# Japan Opinion for TF-BTA Proposals

*Opinion:* Japan supports the proposals [ECE/TRANS/WP.29/GRSP/2014/17](#) and [ECE/TRANS/WP.29/GRSP/2014/31](#), provided that the test area is defined to have an angle  $\theta$  up to 30 deg., as specified in the current regulation.

## Comparison bet. impactor and human model

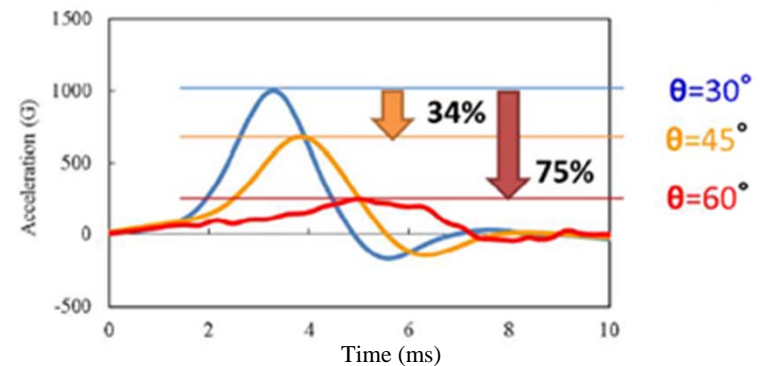
*Reason:* Proper evaluation cannot be guaranteed beyond the 30 deg. area.
